Project	IEEE 802.16 Broadband Wireless Access Working Group < http://ieee802.org/16 >	
Title	Proposed Modifications to the IEEE 802.16m SDD, Section 8	
Date Submitted	2008-03-10	
Source(s)	Yair Bourlas	Voice: E-mail: ybourlas@nextwave.com

Proposed Modifications to the IEEE 802.16m SDD, Section 8

Figure 1 ~~The~~ IEEE 802.16me MS/BS protocol architecture

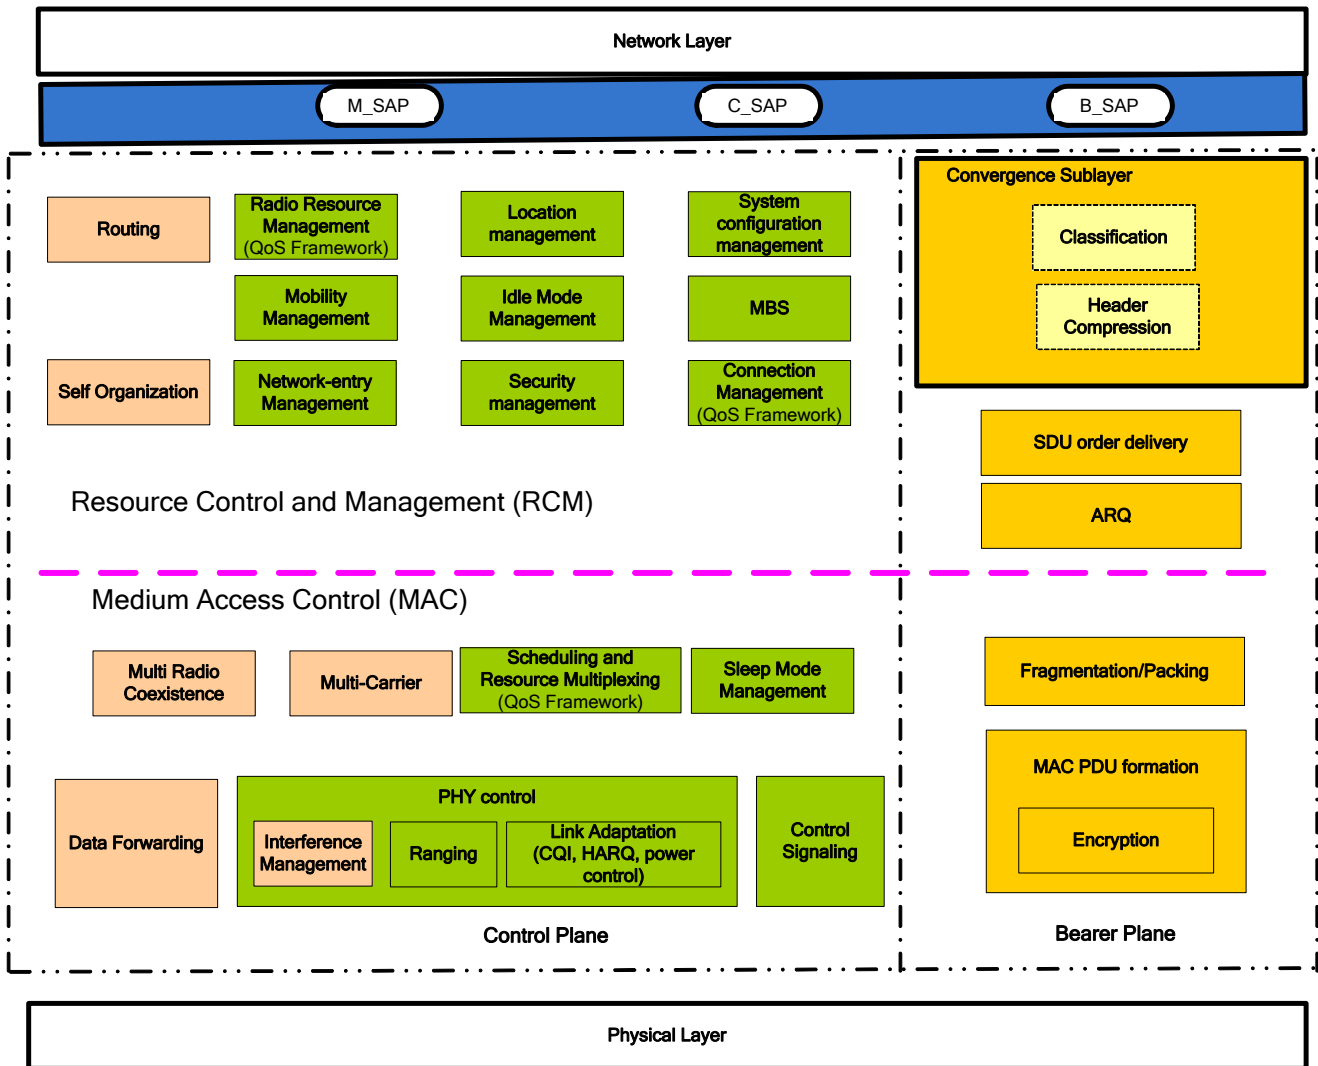
- We propose the partition of the MAC CPS into two sublayers: Resource Control and Management (RCM) and Medium Access control MAC). These terms are already used in the SDD but the SDD does not call them out specially as distinct sublayers

The following Figure 1 shows the protocol architecture of IEEE 802.16me which will be used as reference system. The MAC layer is composed of ~~two~~^{three} sub-layers: Convergence Sublayer (CS), Resource Control and Management (RCM) Sublayer and Medium Access Control (MAC) Sublayer~~MAC Common Part Sublayer (MAC-CPS)~~.

Figure 2 The-IEEE 802.16me MS/BS Data Plane Processing Flow

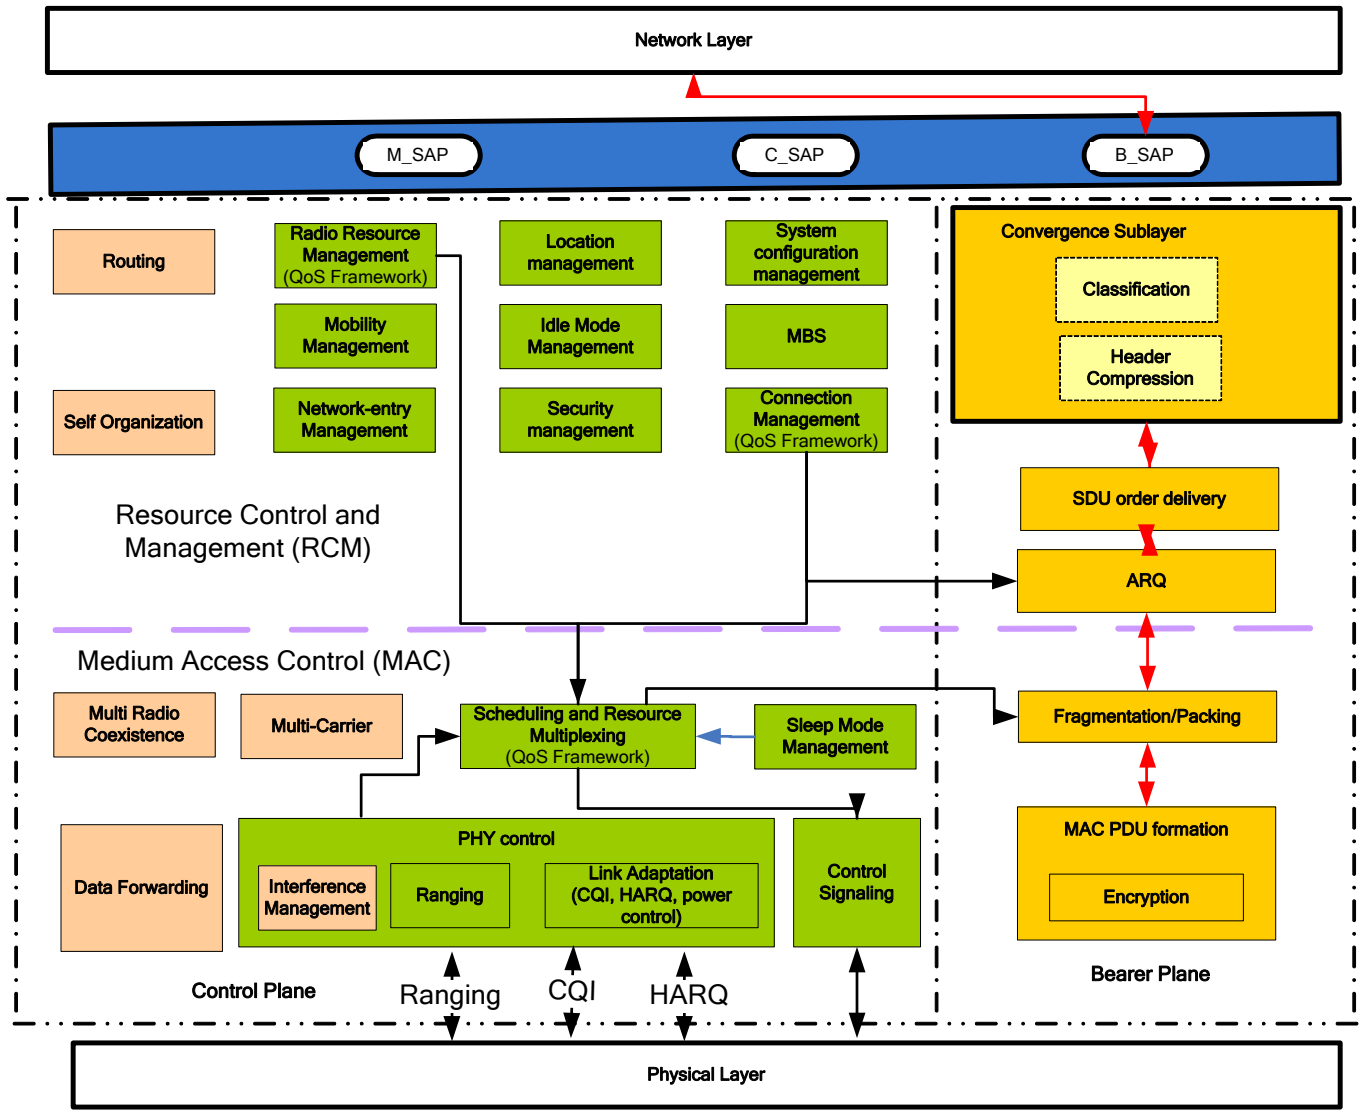
The following Figure shows the user traffic data flow and processing at the BS and the MS. The red arrows show the user traffic data flow from the network layer to the physical layer and vice versa. On the transmit side, a network layer packet is processed by the convergence sublayer, the ARQ function (if present), the fragmentation/packing function and the MAC PDU formation function, to form MAC PDU(s) to be sent to the physical layer. On the receive side, a physical layer SDU is processed by MAC PDU formation function, the fragmentation/packet function, the ARQ function (if present) and the convergence sublayer function, to form the network layer packets. The black arrows show the control primitives among the 802.16m MAC functions and between the 802.16m MAC and the PHY layer that are related to the processing of user traffic data.

Figure 3 The-IEEE 802.16me MS/BS Control Plane Processing Flow

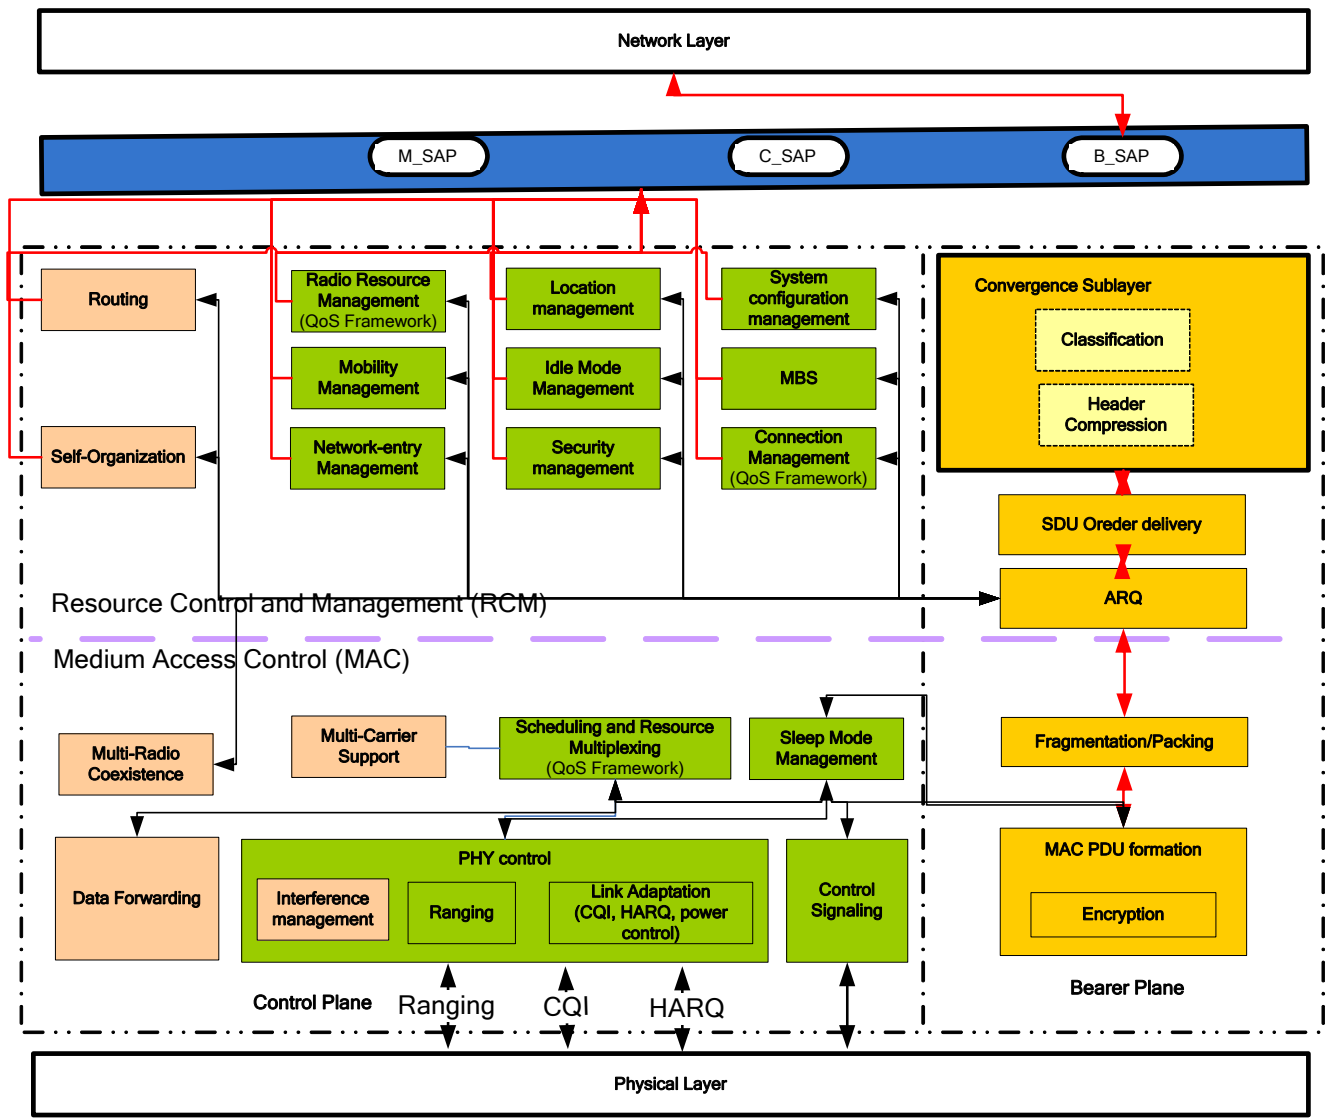
The following figure shows the RCM and MAC control plane signaling flow and processing at the BS and the MS. On the transmit side, the black arrows show the flow of control plane signaling from the control plane functions to the data plane functions and the processing of the control plane signaling by the data plane functions to form the corresponding MAC signaling (e.g. MAC management messages,) to be transmitted over the air. On the receive side, the black arrows show the processing of the received over-the-air MAC signaling by the data plane functions and the reception of the corresponding control plane signaling by the control plane functions. The black arrows show the control primitives among the 802.16m MAC functions and between the 802.16m MAC and PHY layer that are related to the processing of control plane signaling.

Figure 8 The IEEE 802.16m MS/BS Data Plane Processing Flow

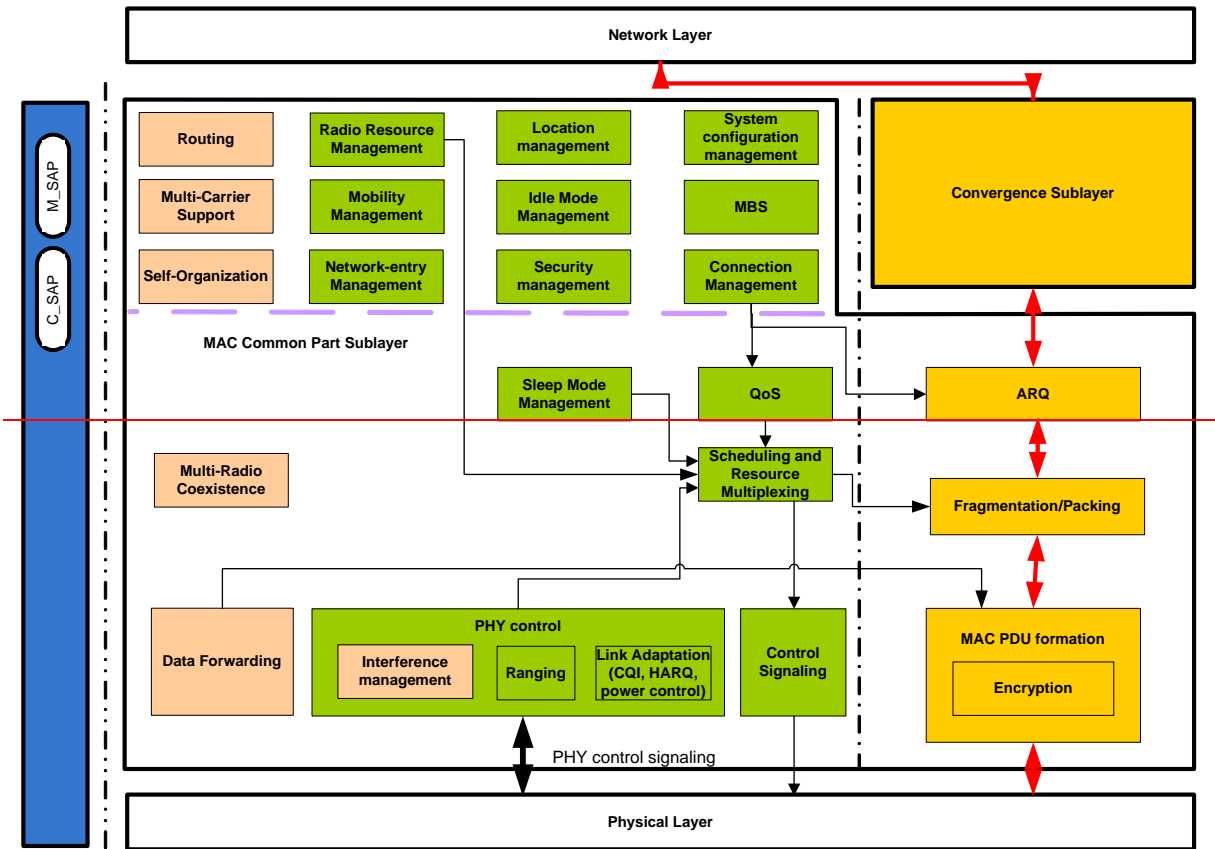
~~The following Figure 8 shows the user traffic data flow and processing at the BS and the MS. The red arrows show the user traffic data flow from the network layer to the physical layer and vice versa. On the transmit side, a network layer packet is processed by the convergence sublayer, the ARQ function (if present), the fragmentation/packing function and the MAC PDU formation function, to form MAC PDU(s) to be sent to the physical layer. On the receive side, a physical layer SDU is processed by MAC PDU formation function, the fragmentation/packet function, the ARQ function (if present) and the convergence sublayer function, to form the network layer packets. The black arrows show the control primitives among the MAC CPS functions and between the MAC CPS and PHY that are related to the processing of user traffic data.~~

Figure 9 The IEEE 802.16m MS/BS Control Plane Processing Flow

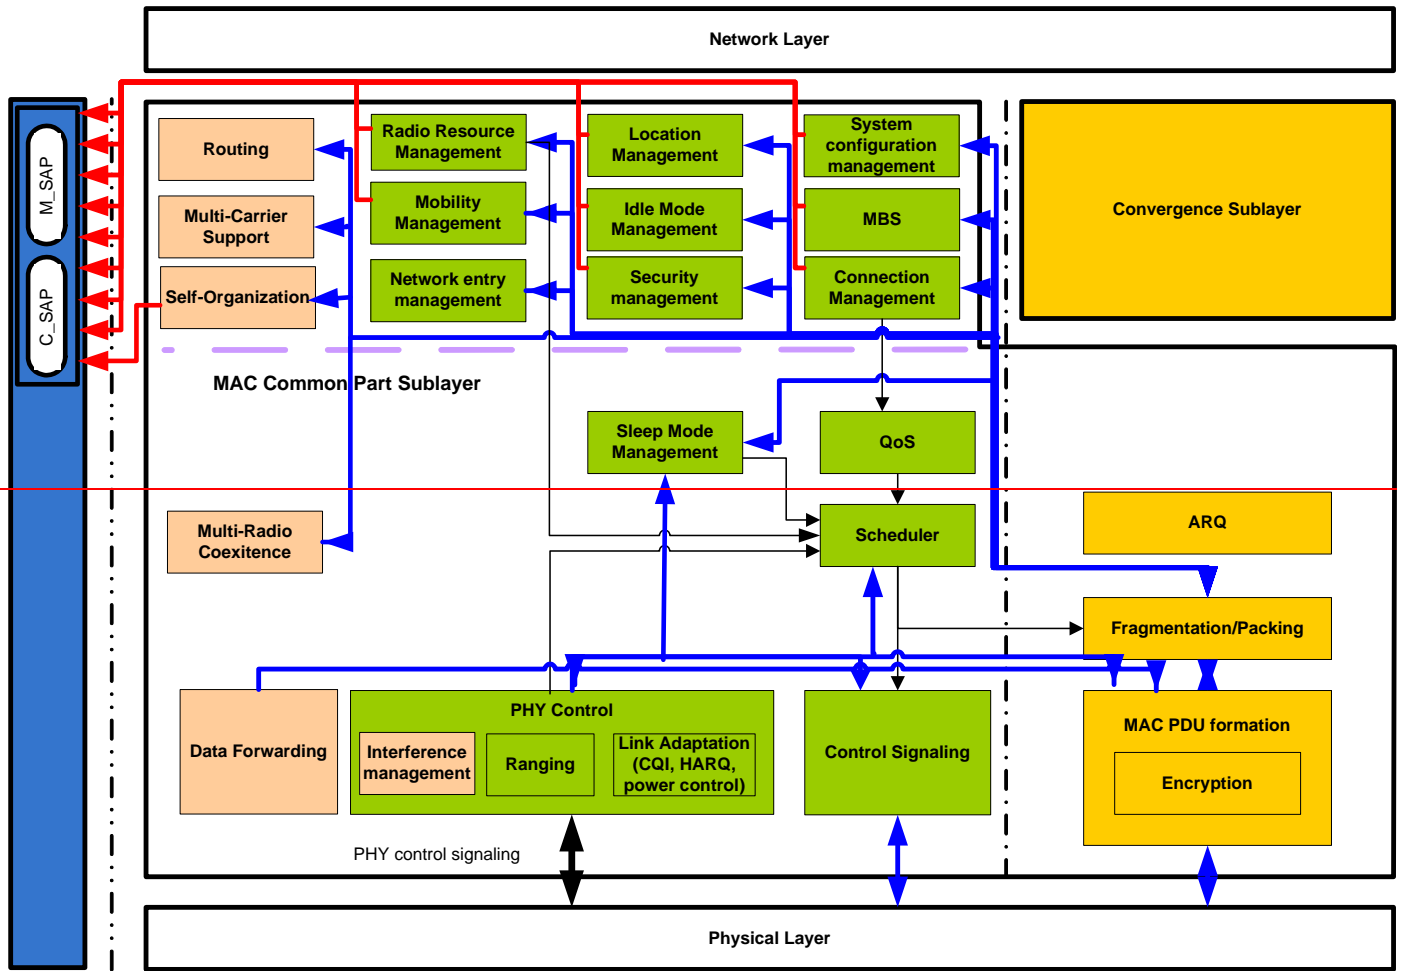
The following figure shows the MAC CPS control plane signaling flow and processing at the BS and the MS. On the transmit side, the blue arrows show the flow of control plane signaling from the control plane functions to the data plane functions and the processing of the control plane signaling by the data plane functions to form the corresponding MAC signaling (e.g. MAC management messages, MAC header/sub-header) to be transmitted over the air. On the receive side, the blue arrows show the processing of the received over the air MAC signaling by the data plane functions and the reception of the corresponding control plane signaling by the control plane functions. The black arrows show the control primitives among the MAC CPS functions and between the MAC CPS and PHY that are related to the processing of control plane signaling.
